**MUNICIPAL SERVICES CENTER, COUNCIL CHAMBER
3600 TREMONT ROAD**

BZAP Meeting Date: May 3, 2023

Subject: 2231 Inchcliff Drive (VAR-17-23) - To allow a two-story addition encroach up to five feet into the 10-foot minimum rear yard setback and up to 7'-5" into the rear yard profile limit.

Existing Abington Road Elevation

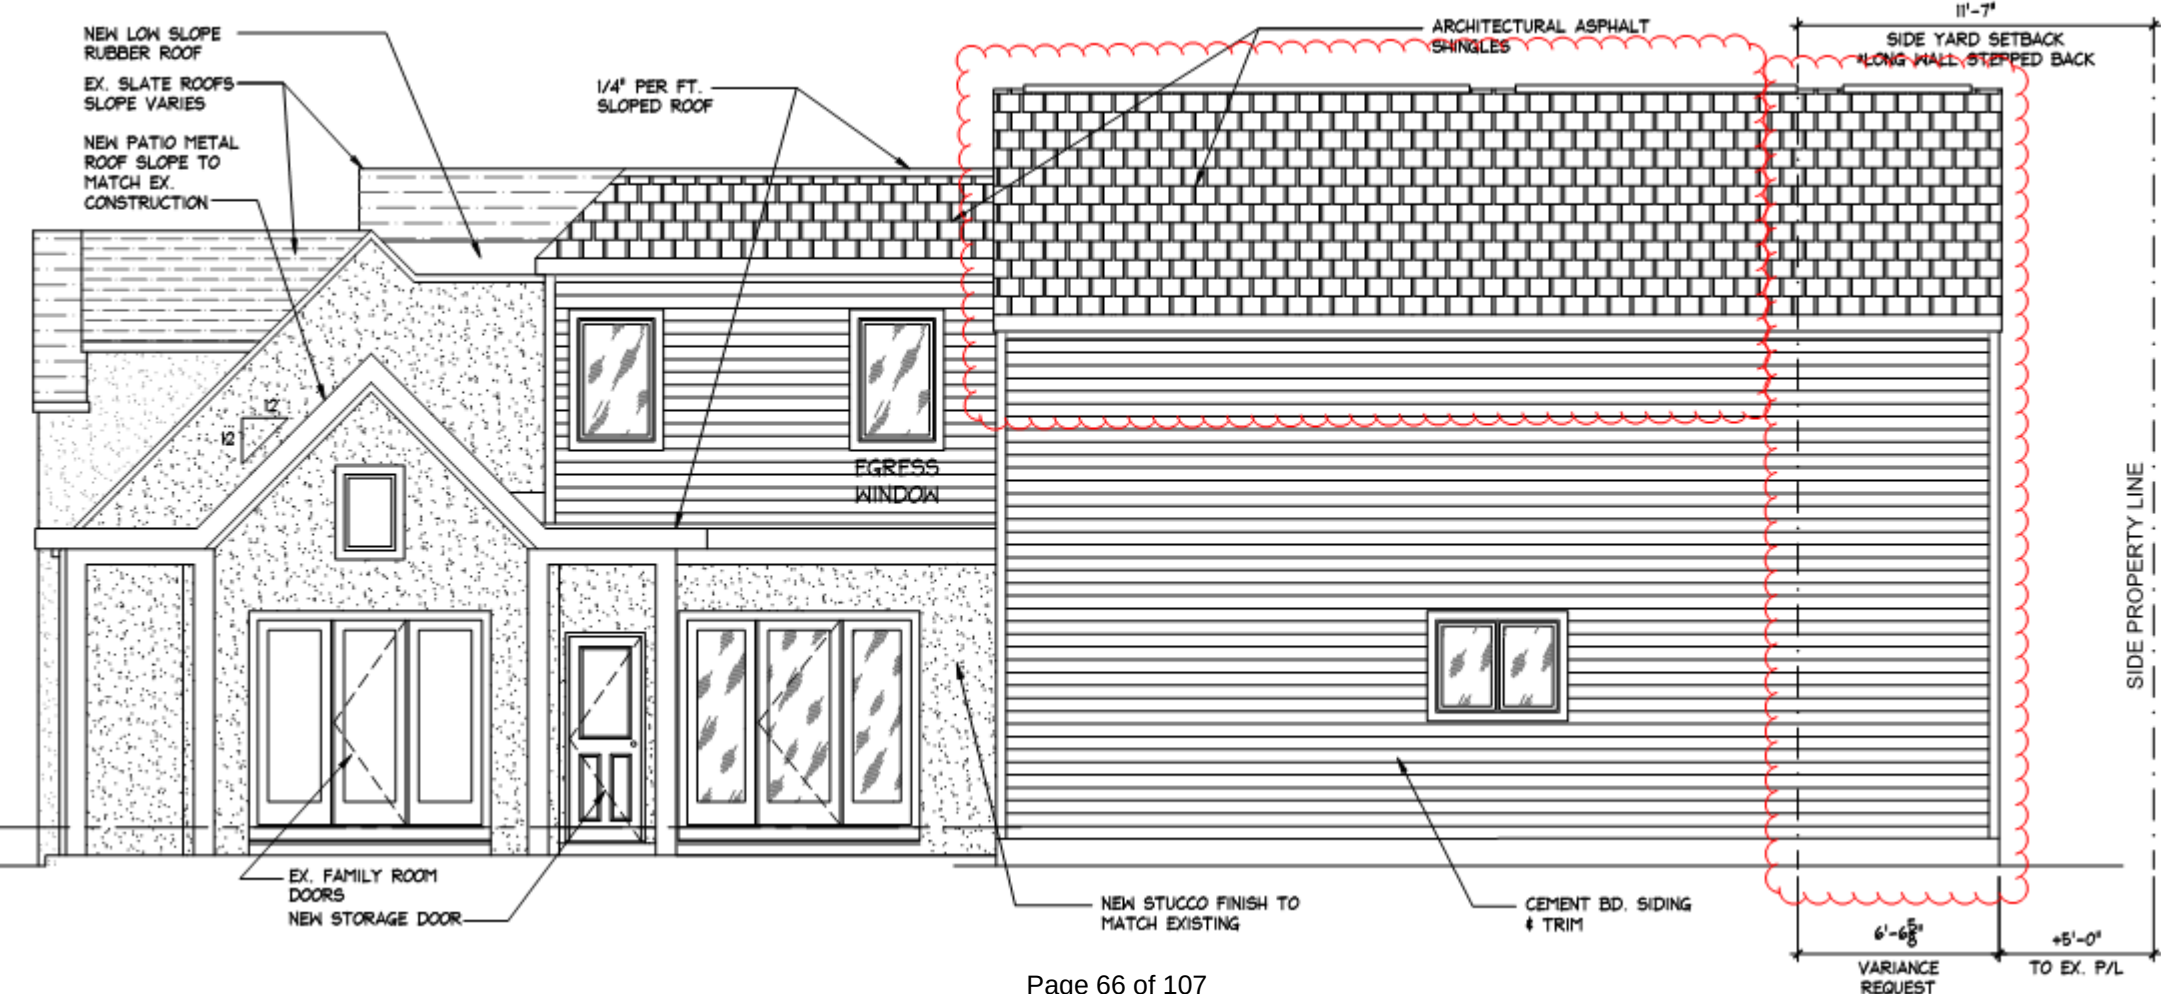
Therefore, Staff cannot recommend approval of the application as submitted. Staff would recommend postponing the case to a Work Session, where the Board may be able to review

alternative designs and provide additional feedback to the applicant. The Board may consider Findings #3 and #4 during deliberations.
